Written Testimony by Dr. Barcelona to the 2010 Public Hearing on the LANL  
Resource Conservation and Recovery Act (RCRA) Permit

Technical Memorandum on the Los Alamos National Laboratory (LANL) Ground Water Monitoring Program with an emphasis primarily on the Well Screen Analysis Report - Revision 2 (WSAR-2) (LA-UR-07-2852, May 2007) AR 14684. and the Ground Water Background Investigation Report - Revision 3, (GBIR-3) (LA-UR-07-2853, May 2007) AR14685.

By: Dr. Michael J. Barcelona, Professor and Past Chair, Department of Chemistry, Western Michigan University, Kalamazoo, MI 49008

### Exhibit 3

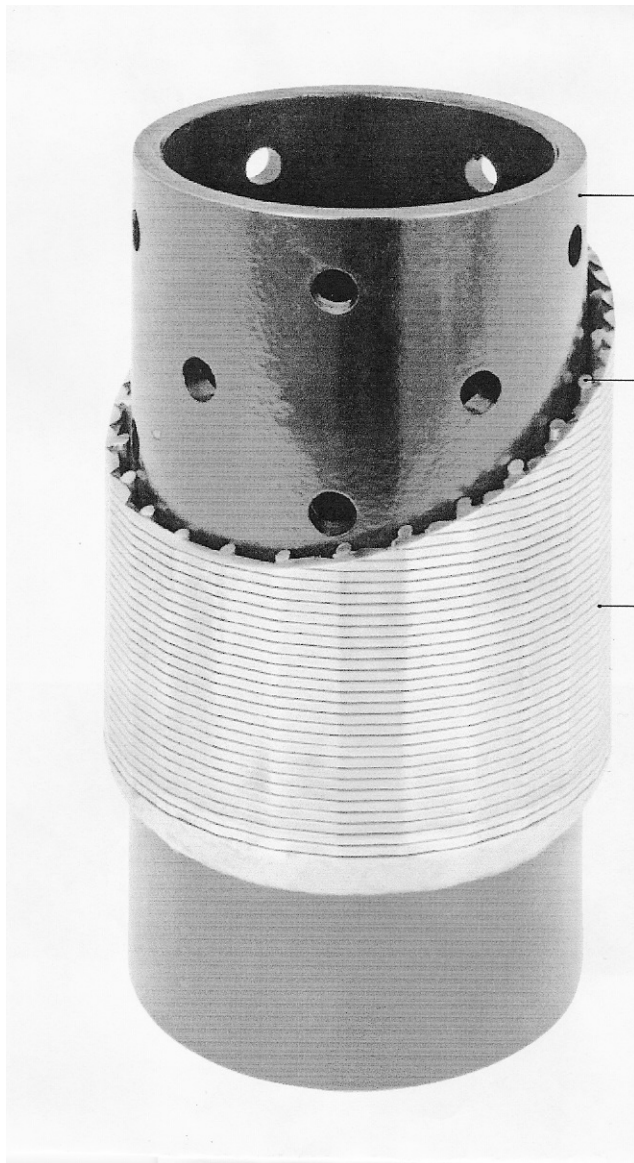
- B). The clay suspended in the drilling fluid would tend to form a paste in the openings in the geologic strata.
  - C). The restrictive pipe-based design of the well screens prevented the extraction methods from removing much of the clay. The restrictive design of the pipe-based screens is displayed in Exhibit 3.

The set of drill holes through the 4.5 inch inside diameter base pipe are only ~15% of the surface area of the stainless steel screen.

Type 304 stainless steel rods are welded to the base pipe and to each wrap of the wire-wrap screen.

The coils of Type 304 stainless steel wire are wrapped around the base pipe with an opening between each coil of one-hundredth of an inch (0.010 inch). One-hundredth of an inch is the thickness of three human hairs.

Exhibit 4  
SCHLUMBERGER<sup>R</sup> GEOPHYSICS IN LANL MONITORING WELL R-22

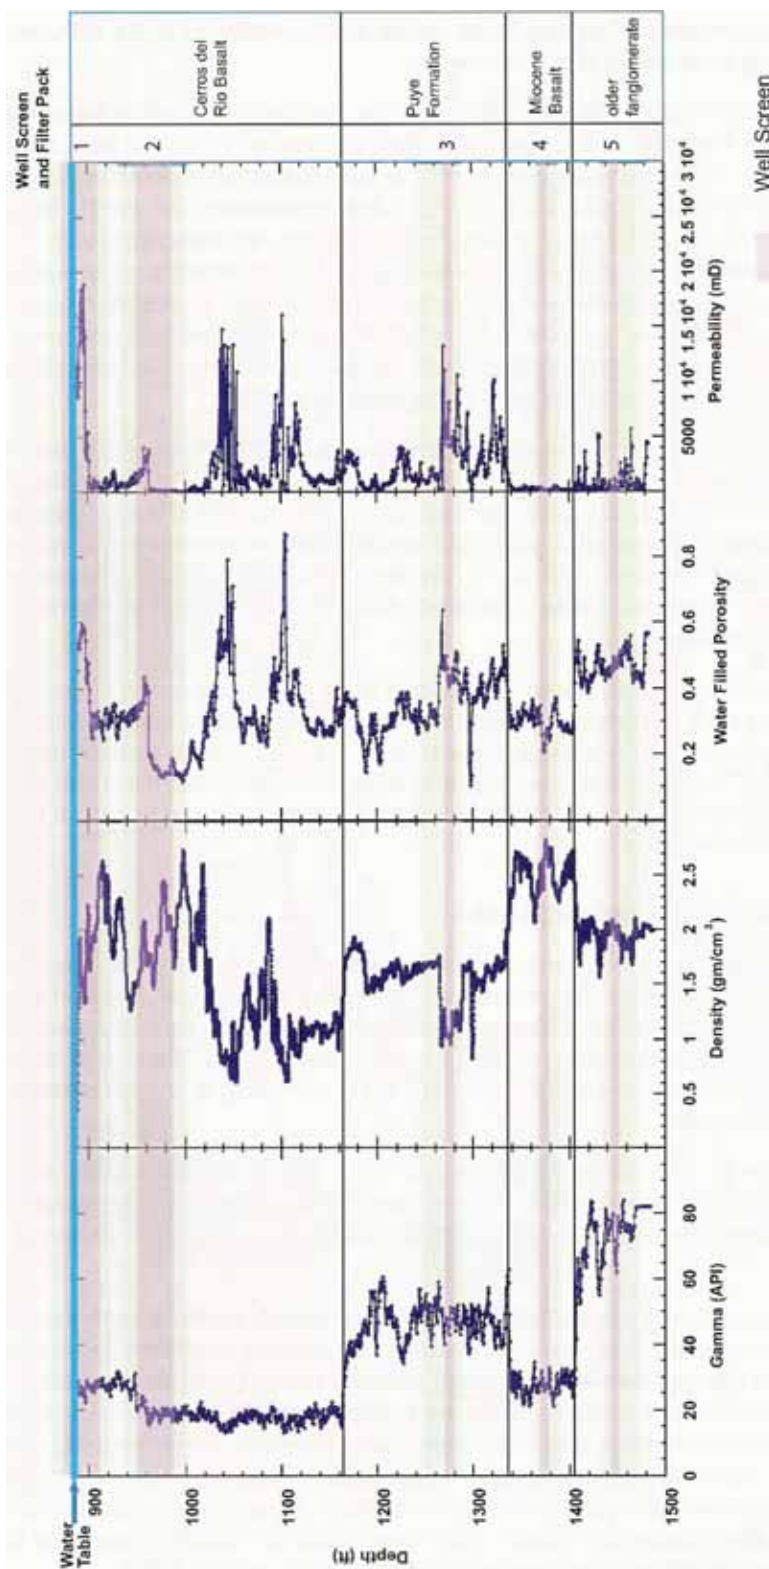
The groundwater contamination measured in the no-purge samples collected from screen five in well R-22 is likely the result of cross-flow of contaminated groundwater within the borehole during drilling from an unknown aquifer zone. In effect, the borehole acts as a conduit for the vertical transport of contaminants. At well R-22, well screens were not installed in apparently high Ksat hydrostratigraphic zones (e.g., the RCRA "uppermost aquifer) that were identified by the drilling operations, the lithologic log or the Schlumberger (Trademark) geophysics conducted in the open borehole.

The apparent current use for well R-22 is measurement of water levels. I would suggest strongly that NMED require installation of a minimum of two new single-screen monitoring wells near the location of well R-22 to investigate potential groundwater contamination down-gradient of MDA G. One well should be installed a short distance below the water table. The other well should be installed in the high permeability strata that are

present approximately 150 feet below the water table. See Exhibit 4, the suite of Schlumberger geophysics logs for well R-22.
